Subject: **Request for Modification of the Section 404 Individual Permit and Section 401 Water Quality Certification** for the proposed NC 24/27 Troy Bypass from west of SR 1138 (Dairy Road) to just east of Little River, Montgomery County, Division 8. WBS Element No. 34352.1.1, TIP No. R-0623 Debit \$570.00 from WBS Element No. 34352.1.1

In addition to this cover letter, please find enclosed the revised Division of Mitigation Services (DMS) Acceptance Letter, revised permit drawing sheet nos. 1, 55, 56, 90, and 91 as well as 4 additional permit drawings.

The modification request is to accommodate a request from the Town of Troy. The design was revised to provide a free movement connection to the town. Public officials felt an intersection would discourage travelers and make it difficult for locals who have always had free movement to the town. A grade separated crossing has been added on Troy-Candor Road over the Troy Bypass, along with connecting roadways in the northwest and southeast quadrants. These changes will replace the directional crossovers and U-turn bulb outs along the Troy Bypass in the vicinity of Troy-Candor Road. In addition, these changes will allow for uninterru

Permit Drawing  
Sheet 1 of 4  
Added 5/13/2016

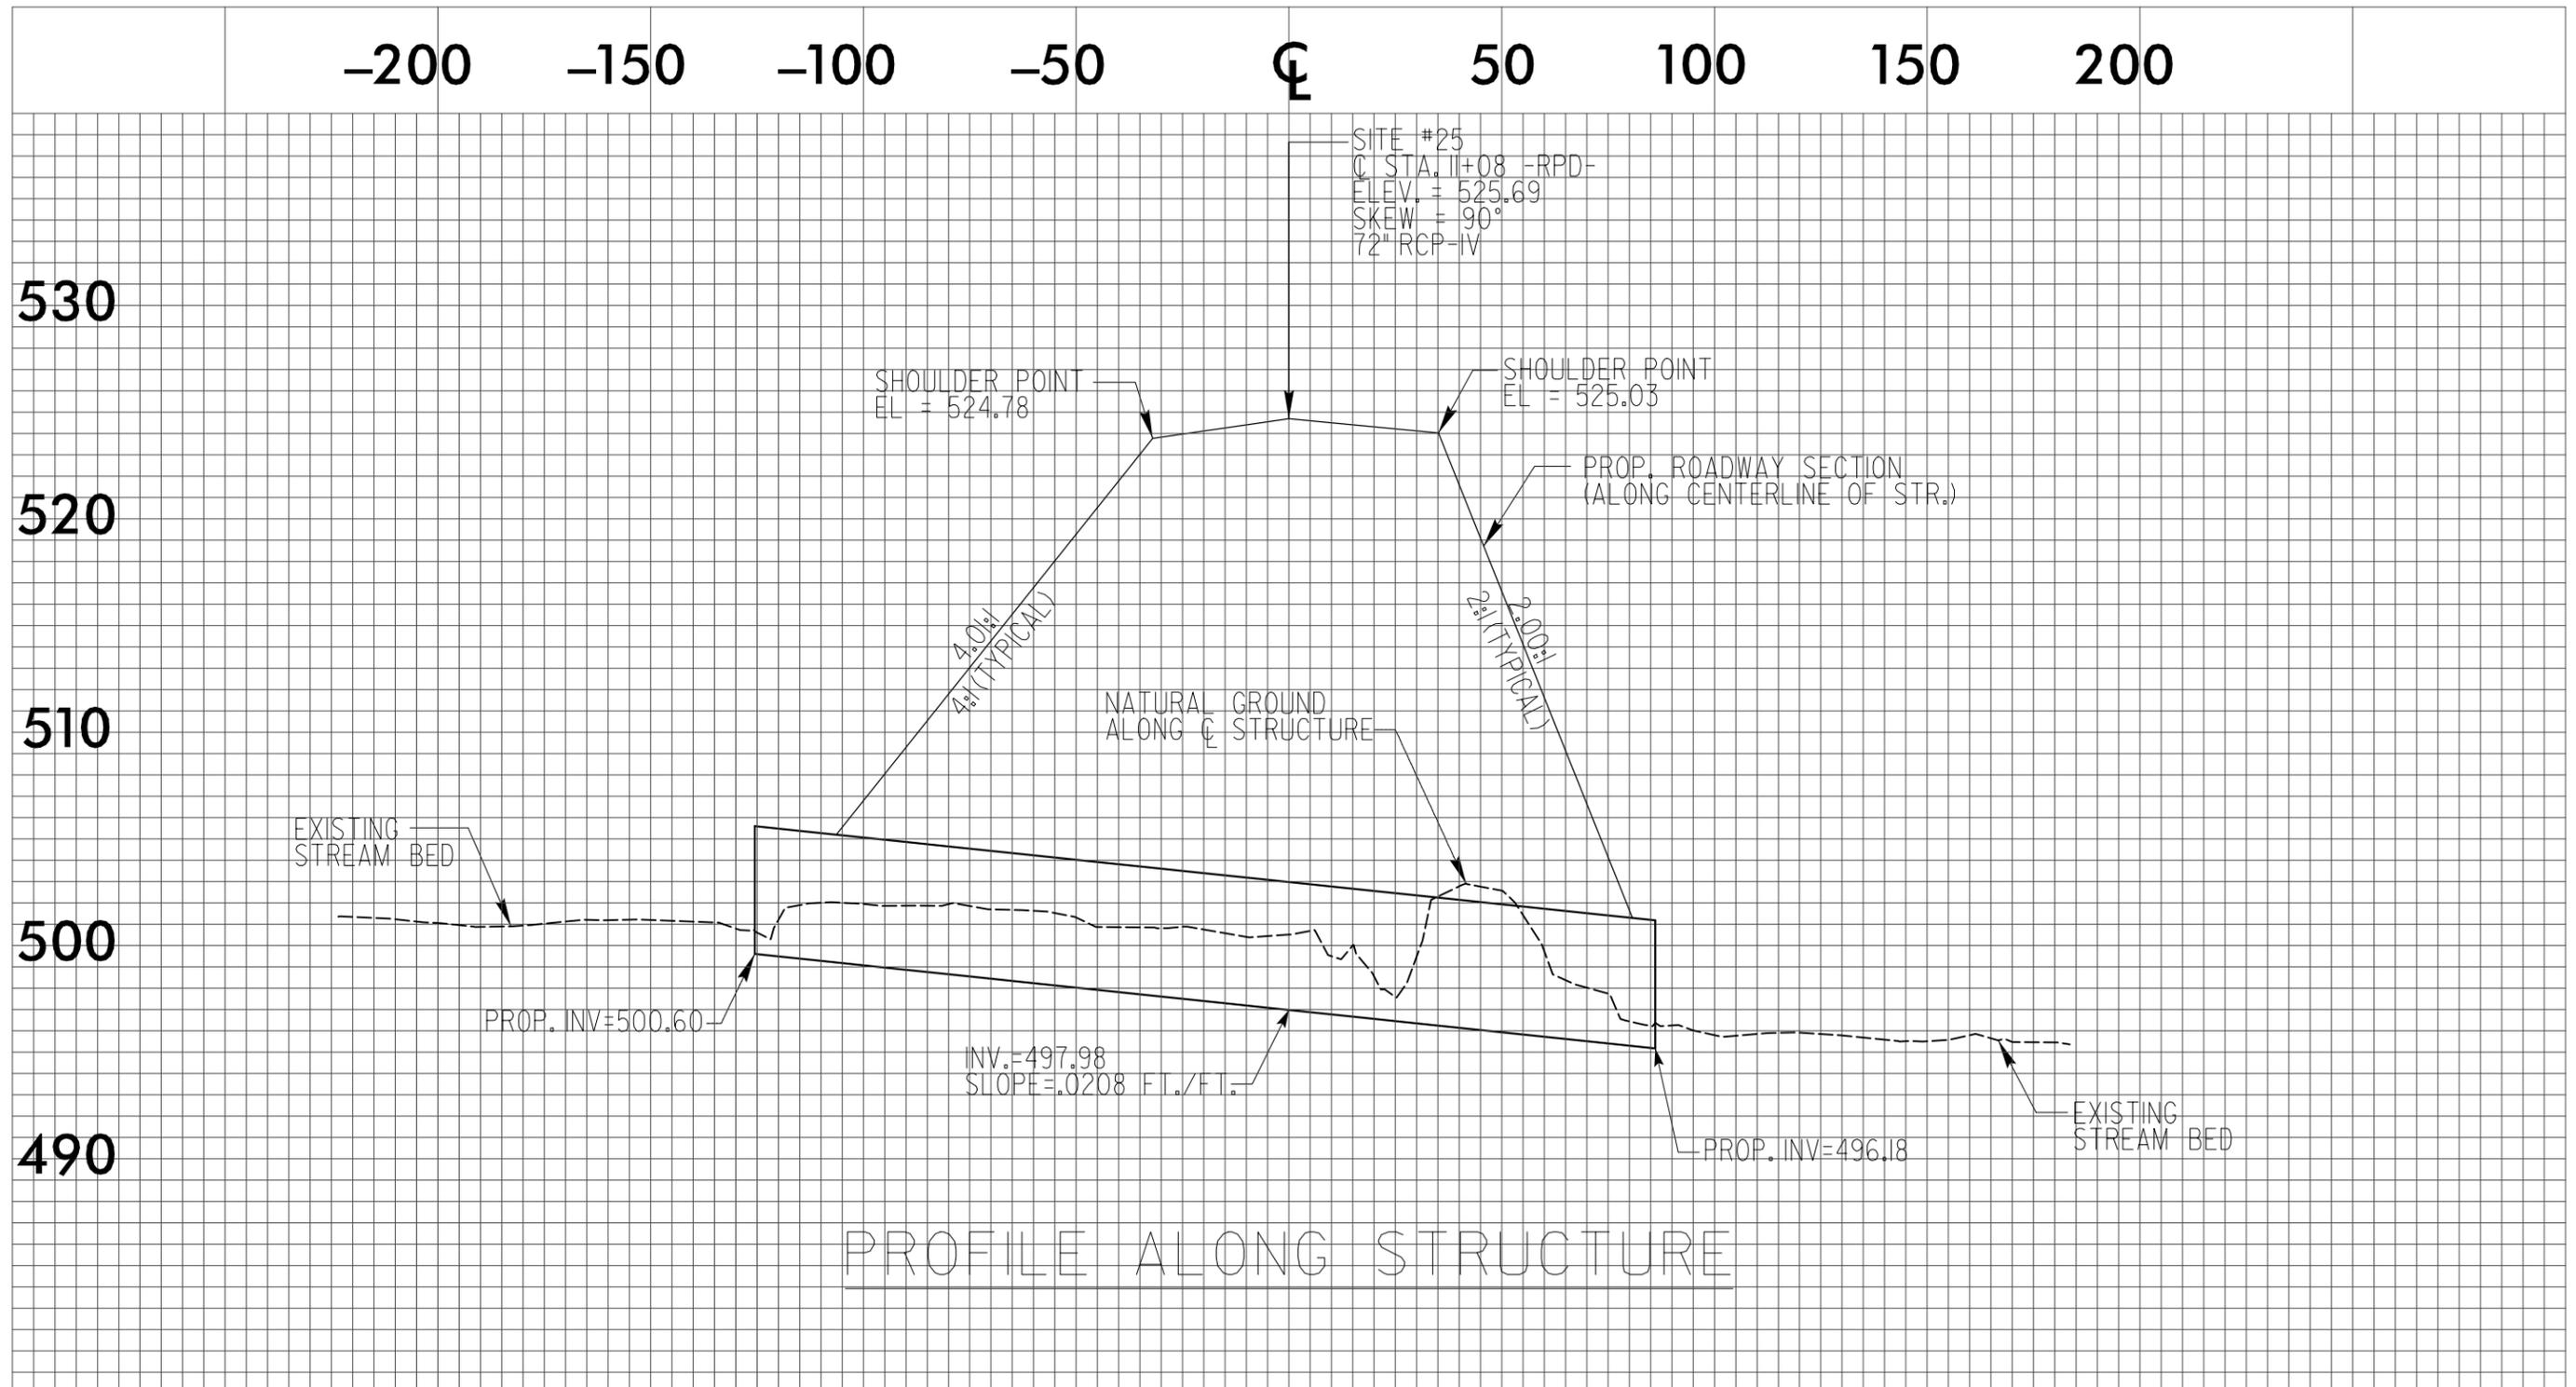
- An additional 38 feet of permanent stream impacts have been added to permit site 15 due to bank stabilization associated with the 66" culvert.
- Stream impacts for new permit site 25 are associated with the stream crossing at the proposed Ramp D due to a 72" culvert. This will result in 270 linear feet of permanent and 28 linear feet of intermittent stream impacts for this site.
- Stream impacts for new permit site 26 are due to raising the grade on Troy-Candor road to accommodate the new interchange. This will result in 66 linear feet of permanent impacts, 7 linear feet of temporary impacts, and 8 feet of bank stabilization.

# SITE 25

Permit Drawing  
Sheet 4 of 4  
Added 5/13/2016

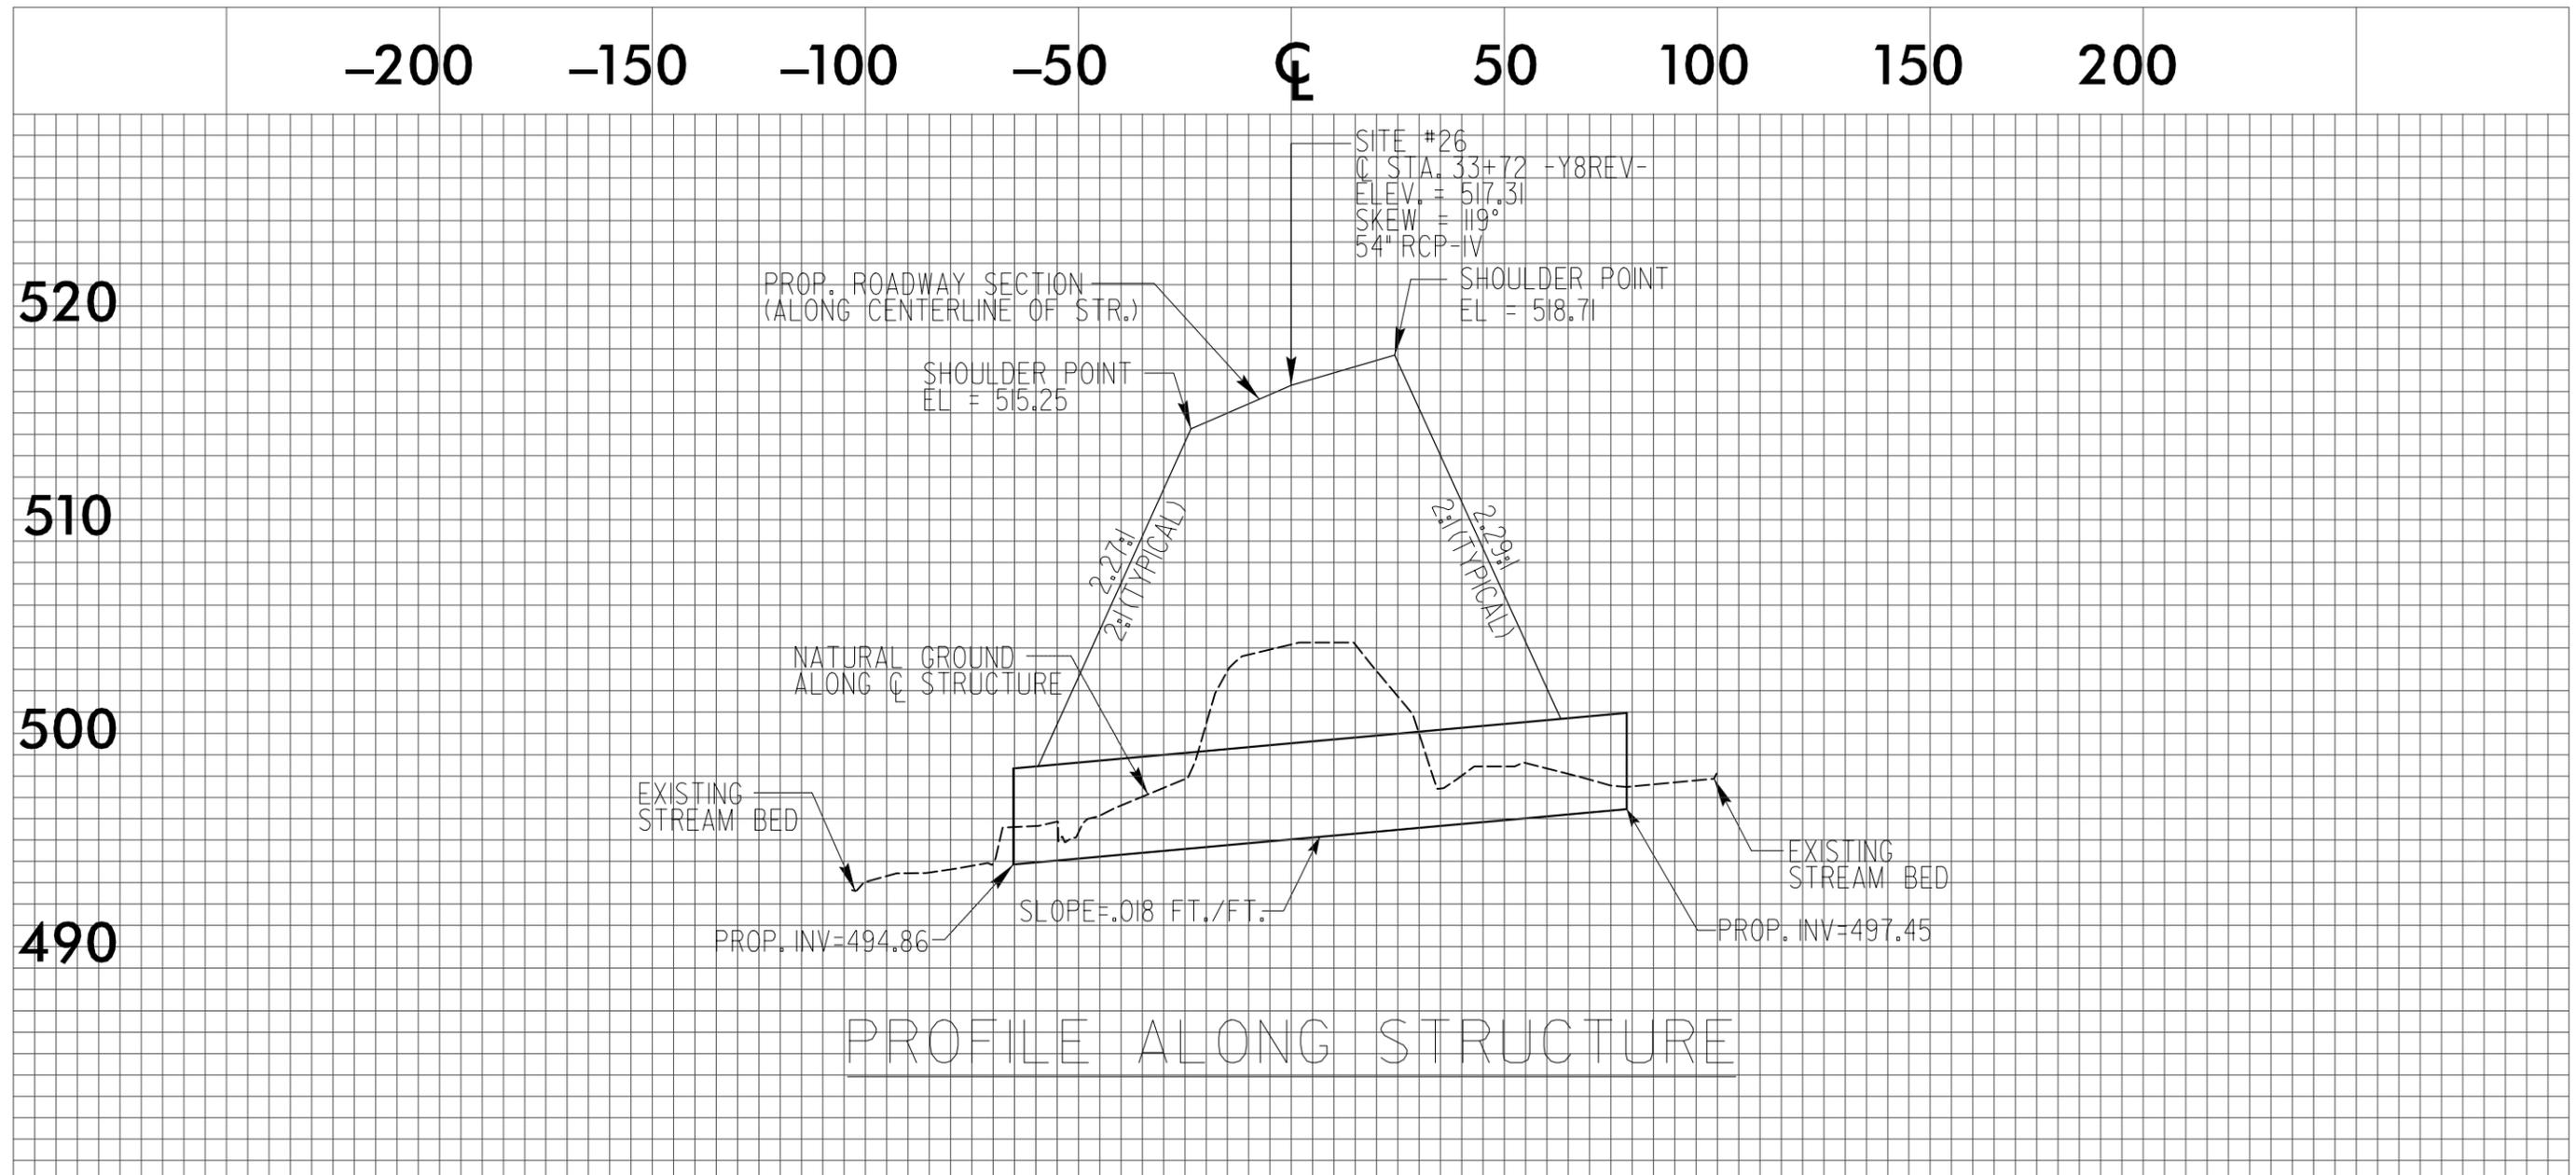
# SITE 26
